LHC

REFERENCE
LHC-BGC-EC-0003

ENGINEERING CHANGE REQUEST

Update of the BGC Phase 1 installation and move of the gas injection system.

Figure 1: Amorphous carbon coating of the vacuum chamber (LHCBGCAB0013) and copper liner (LHCBGCAB0026).

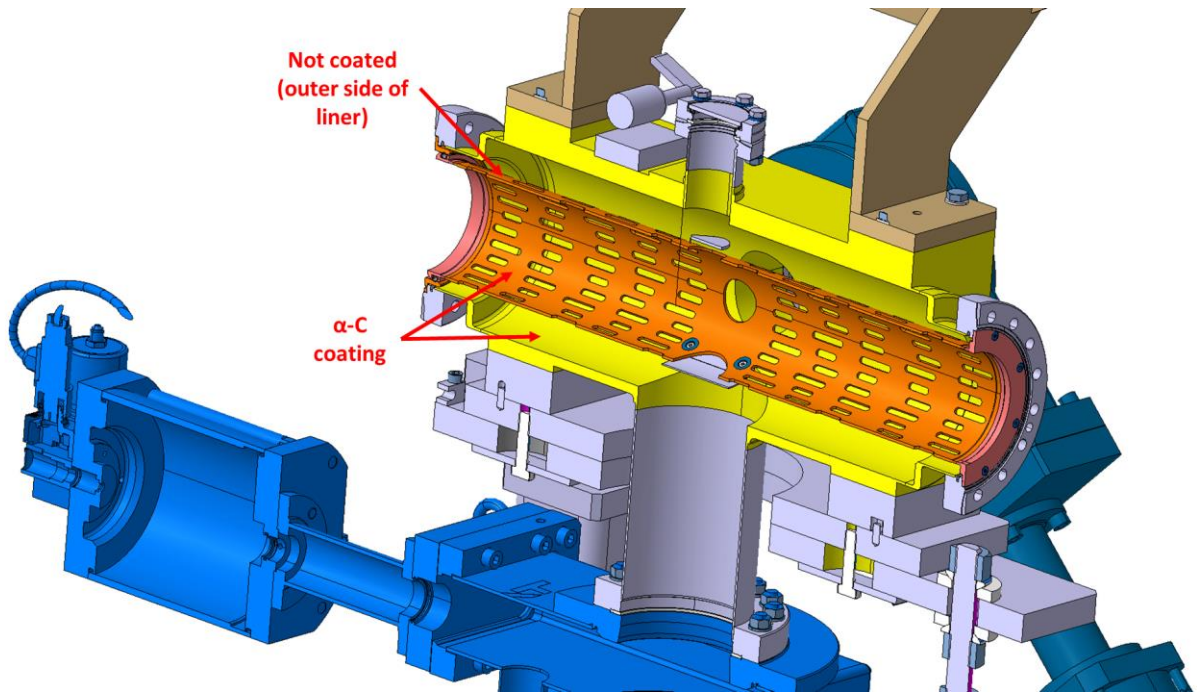
Amorphous carbon coating is chosen both for the internal side of the liner and the inner side of the vacuum chamber due to its low reflectivity for visible light, see Figure 1. There is good in-house knowledge of this technology, proven vacuum and electron cloud compatibility as well as the low reflectivity of about 13% [3].

Figure 2: Multi-layer coated low reflectivity plate (LHCBGCAB0006).

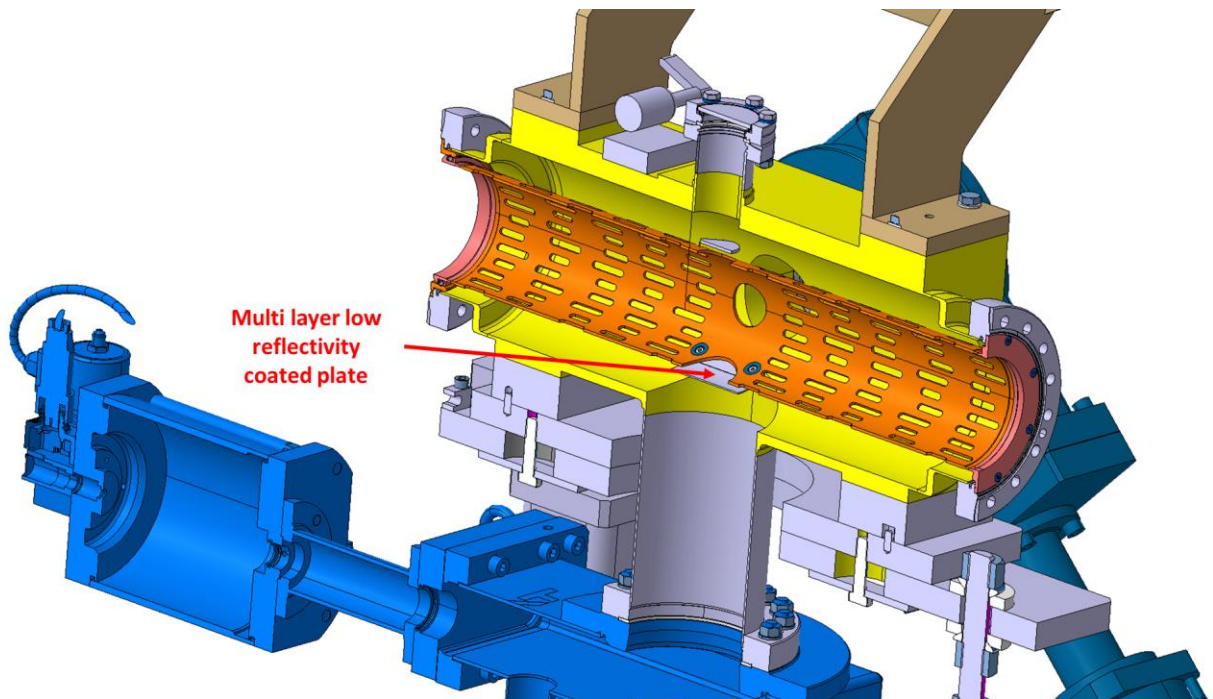
The plate which is seen by the camera will have a very low reflectivity multilayer coating made of Ti, Al, Si, O, N, see Figure 2. The outgassing of this coating is LHC UHV compatible [4].

The surface of the plate will be coated by magnetron sputtering. The first three layers are coated with a TiAl magnetron-electrode. TiAl is the base layer. Nitrogen is then injected into the chamber and a layer of TiAlN is created. A top layer of TiAlON is then created by adding oxygen to the nitrogen atmosphere in the chamber. A last layer of SiO₂ is added with a second magnetron of silicon. The total thickness of the coating is in the range of 400 nm.

Figure 3: Design of the support structure (LHCBGCAB0014).

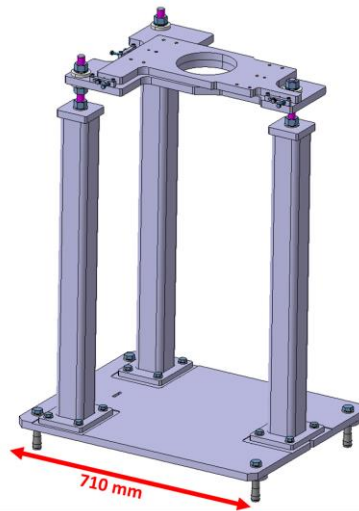
The footprint of the support structure slightly exceeds the 500 mm space allocated for the BGC. The design of the BGC support has to reflect the accessibility to assemble the individual parts, namely the voluminous all metal gate valves. The design of the support is 710 mm long with the footprint and two gate valve entering into the adjoining VSC sectors, see Figure 3 and Figure 4.

Figure 4: Clearances of the valves to the adjacent vacuum supports

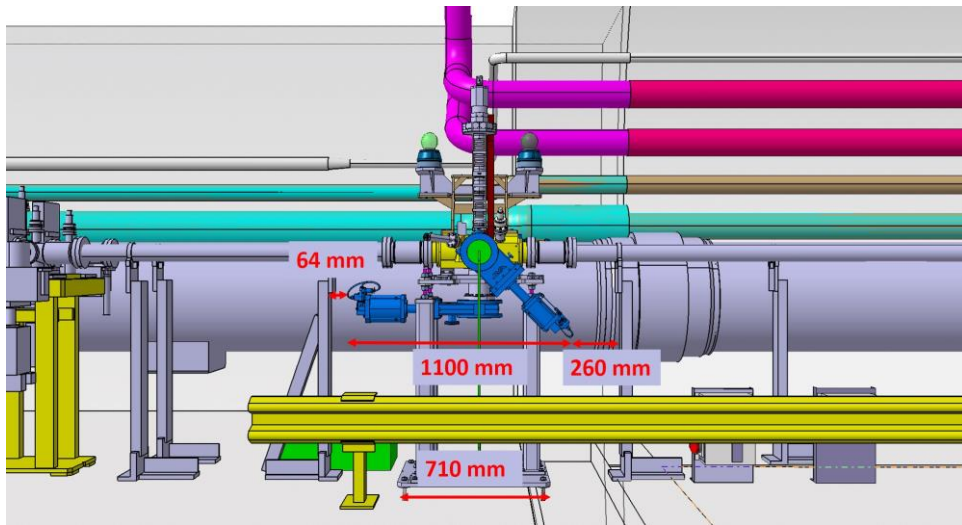
In order to have more space between the BGC valve on the left side towards the VSC tube support, we request to move the support by 60 mm to increase the space from 64 mm as seen in Figure 4 to 124 mm.

Figure 5: Position with survey (red) and tunnel (yellow) stay clear. The optical target on the BGC is demountable if requested during alignment activities in the tunnel.

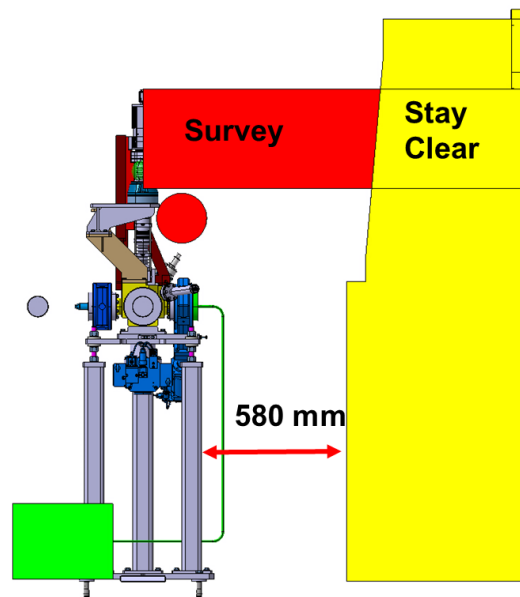
The optical assembly and the geometer targets as seen Figure 5 can be temporarily demounted if requested.

Figure 6: Randomised slot pattern of BGC liner

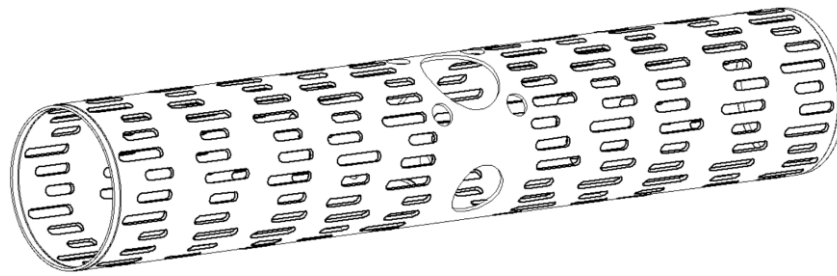
In order to minimise the impedance, a beam screen type slot pattern with randomised slot locations and dimensions was selected, see LHCBGCAB0008 for details. The present design was presented and approved by the Impedance Working Group [5].

Figure 7: BGC phase 1 installation with the gas jet horizontal position.

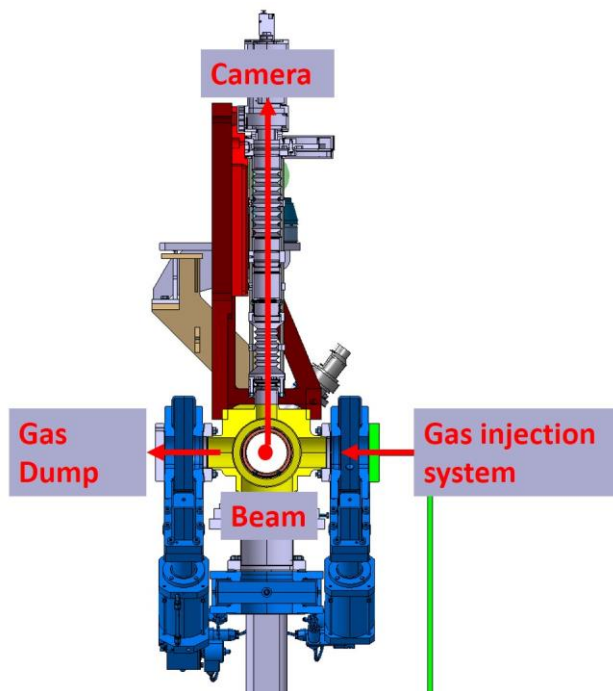
The final Phase 2 gas jet (not part of this ECR) will be mounted in the horizontal plane [6]. An engineering solution to fulfill this requirement while fitting within the allocated space without entering the tunnel stay clear has been found. The preparation and orientation of the instrument will be already be implemented for in Phase 1, with the Phase 1 layout shown in Fig 7.

Figure 8: BGC Phase 1 with gas injection position in the tunnel.

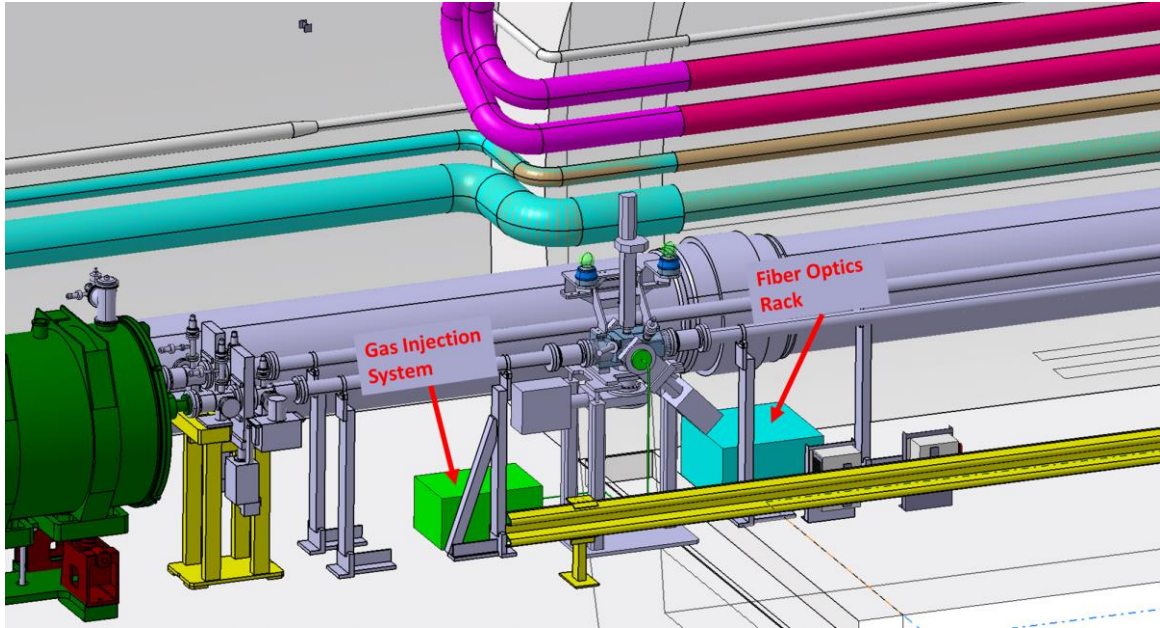
move the gas injection of the former BGI DCUM 9932 to the BGC Phase 1 location DCUM 9955 during LS2, see Figure 8, Figure 9 and Annex 1.

All functionalities including the maximum gas injection pressure of $5 \cdot 10^{-8}$ mbar will remain the same as for the present BGI gas injection system. Some of the gas injection control cables might need short extensions. The gases to be tested are neon, argon and nitrogen with a focus on neon. All gas types used will first be approved by TE-VSC.
